Drainage Report Final_V1.pdf Markup Summary

TRI-STATE GENERATION & TRANSMISSION, INC.

December 16, 2021

FOX RUN SUBSTATION DRAINAGE REPORT

Appendix A Site Maps & Design Drawings

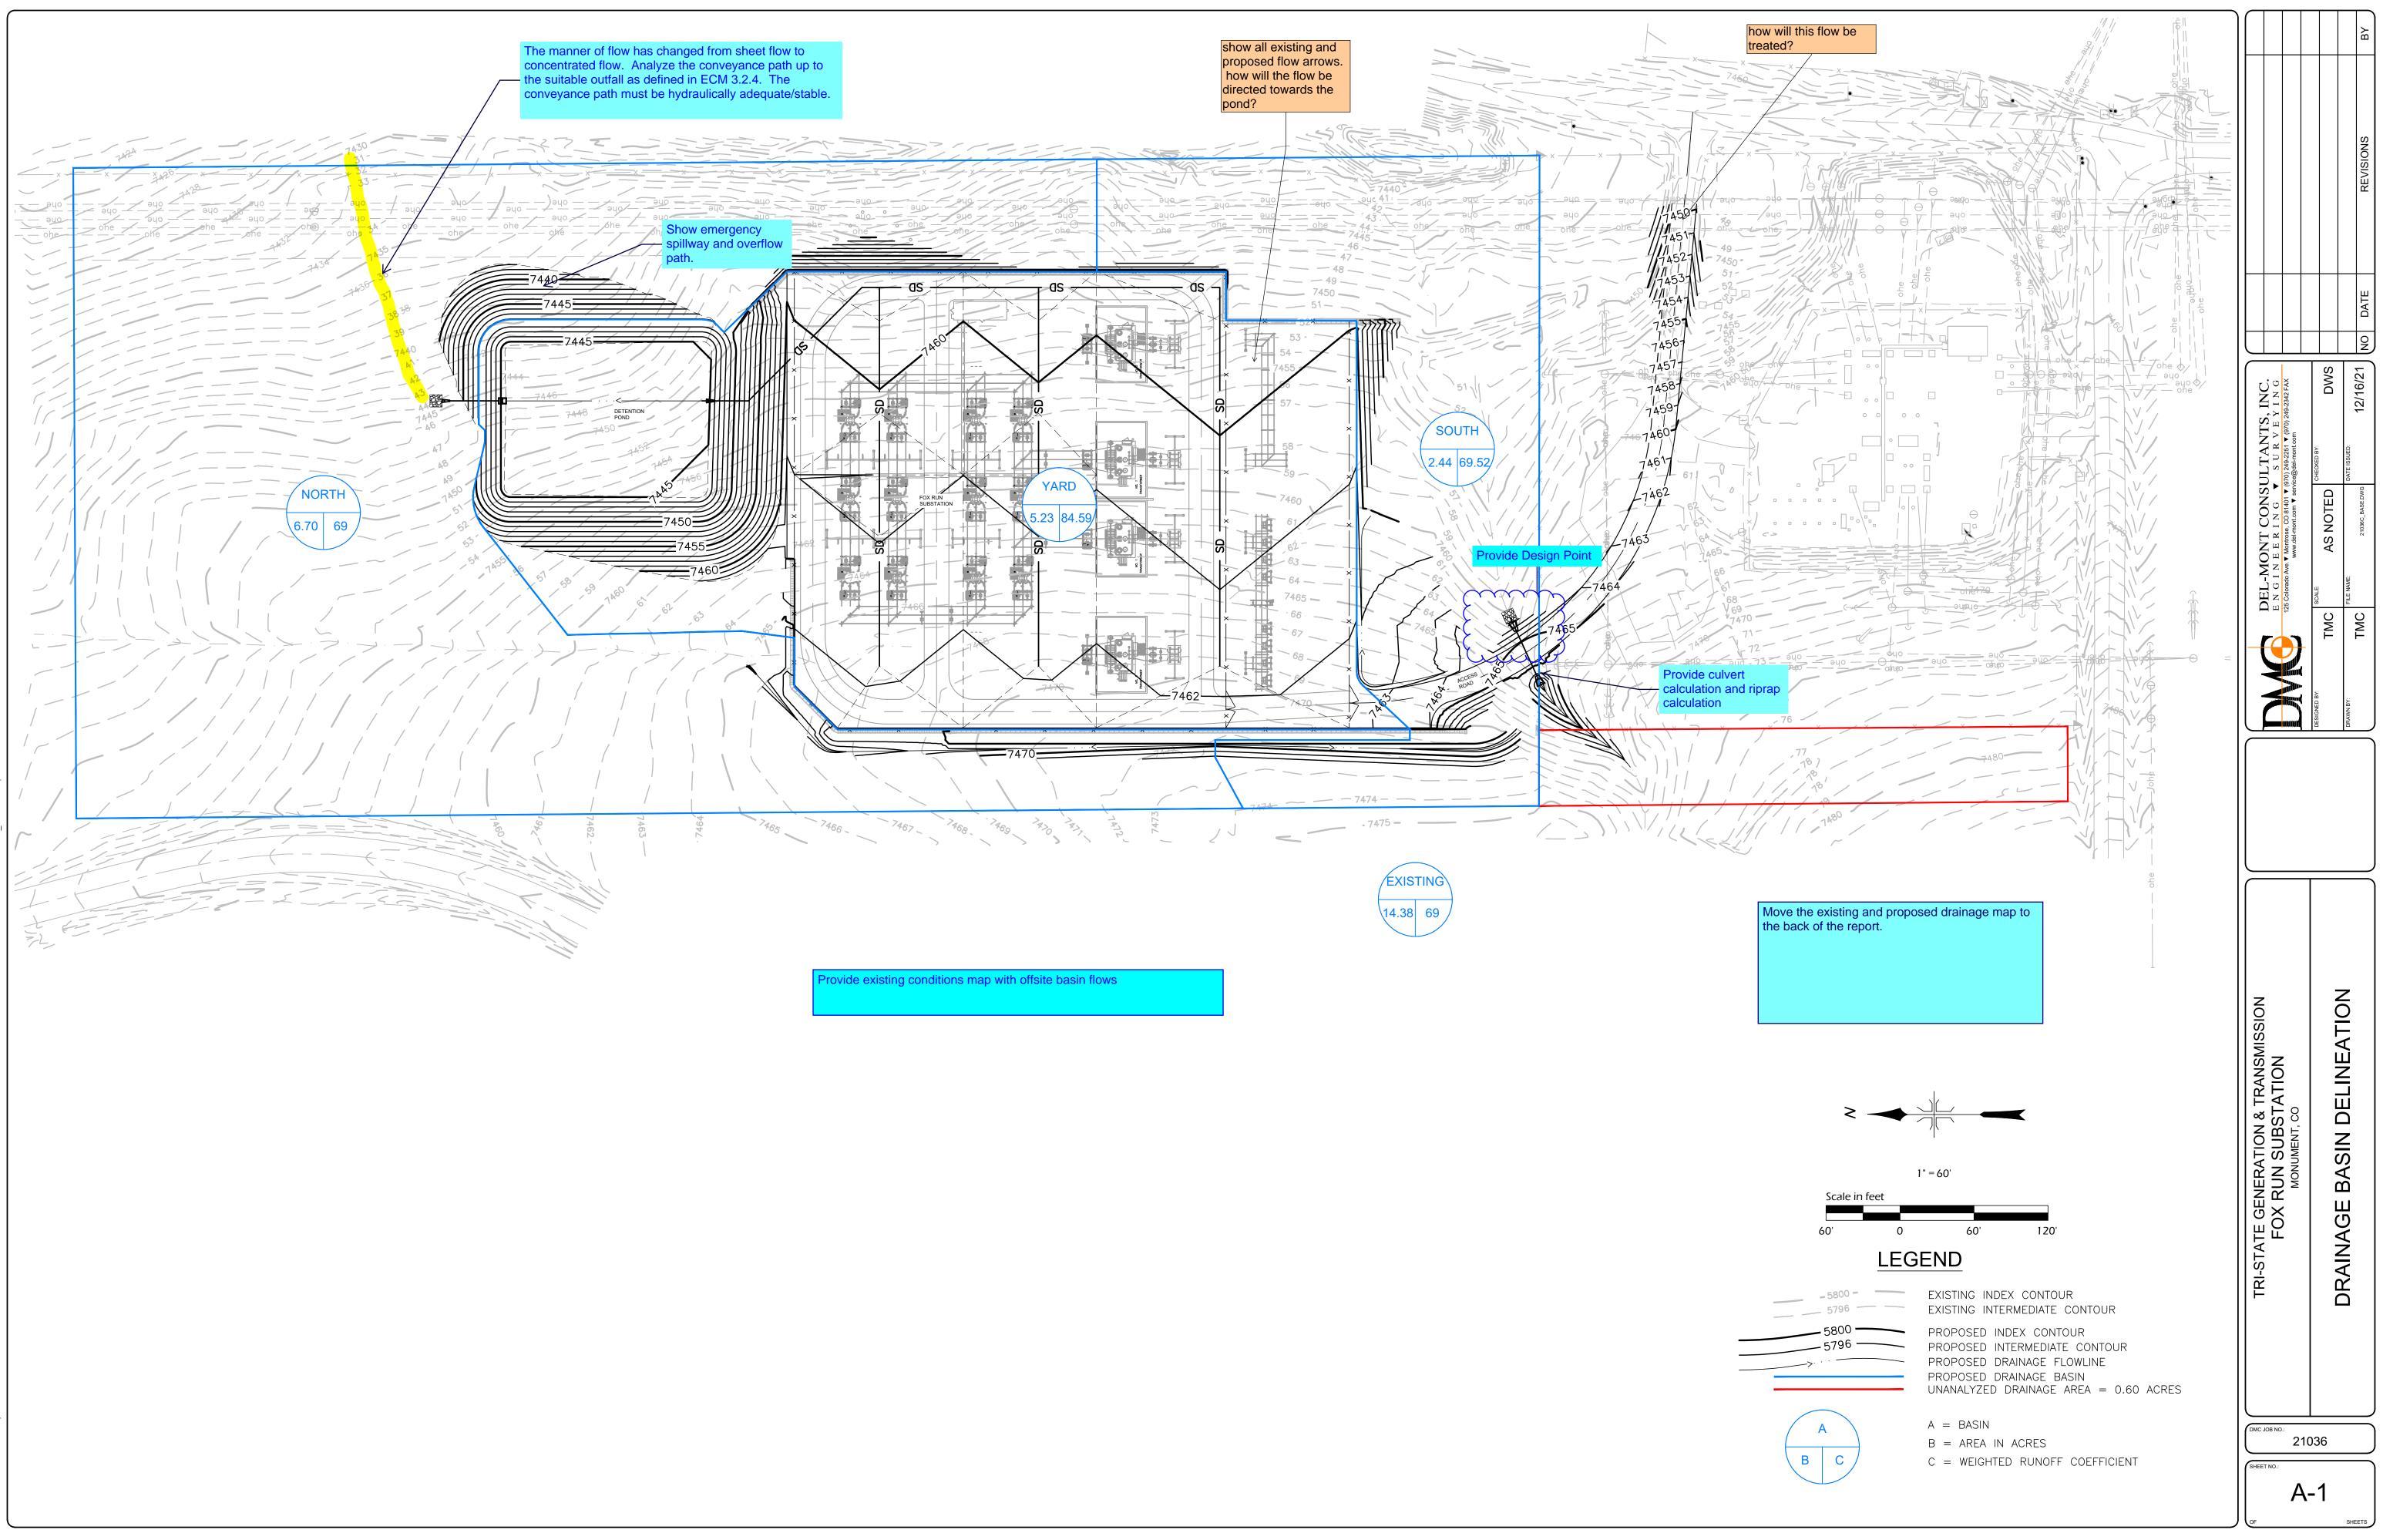
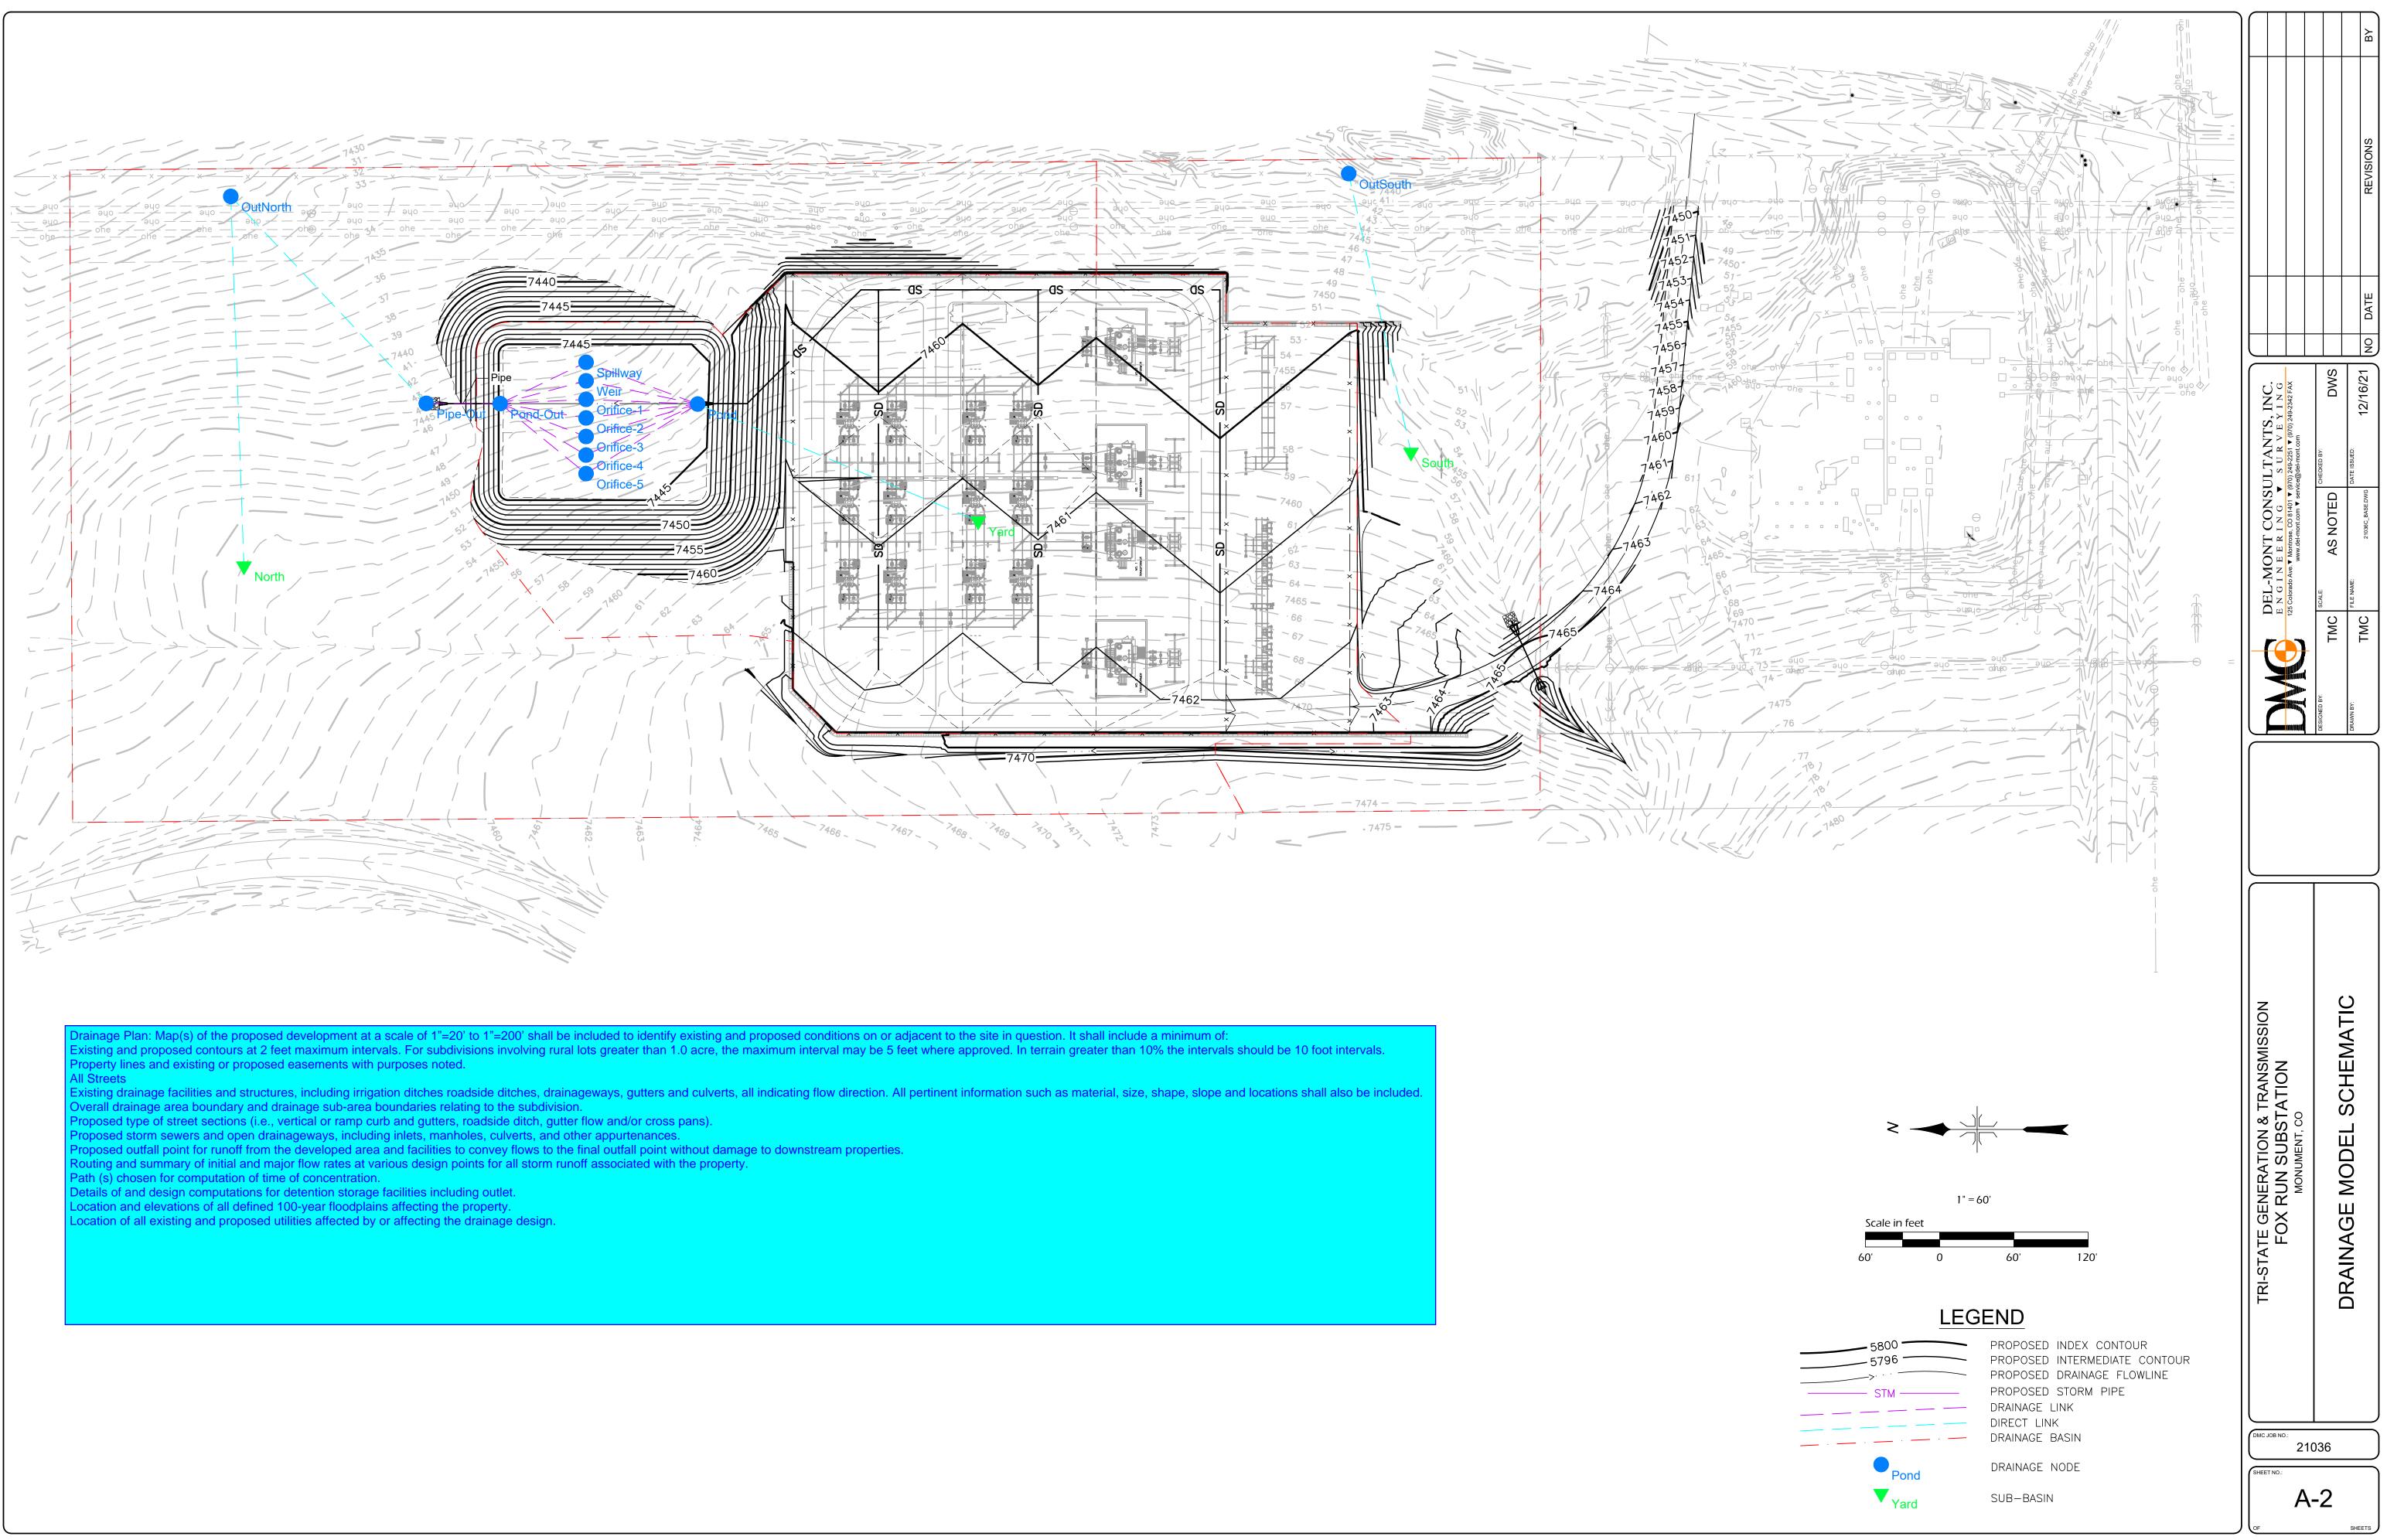
Provide drainage ditch calculations and riprap outlet protection calculations

include MHFD BMP Spreadsheet for forebay, trickle channel, and micropool calculations.

DETENTION BASIN STAGE-STORAGE TA<u>BLE BUILDER</u>

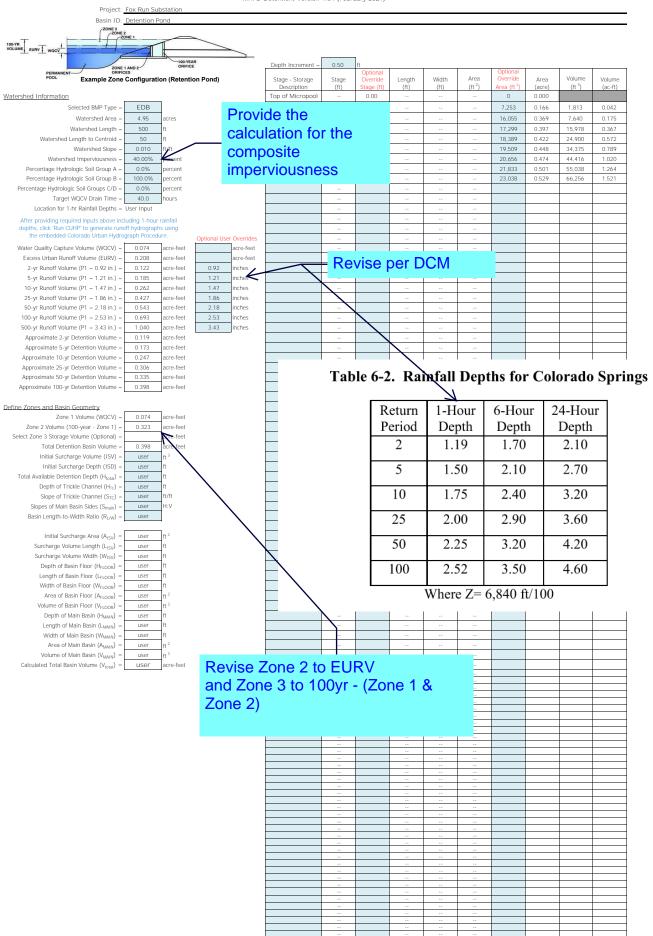
Revise Zone 2 to EURV and Zone 3 to 100yr - (Zone 1 & Zone 2)
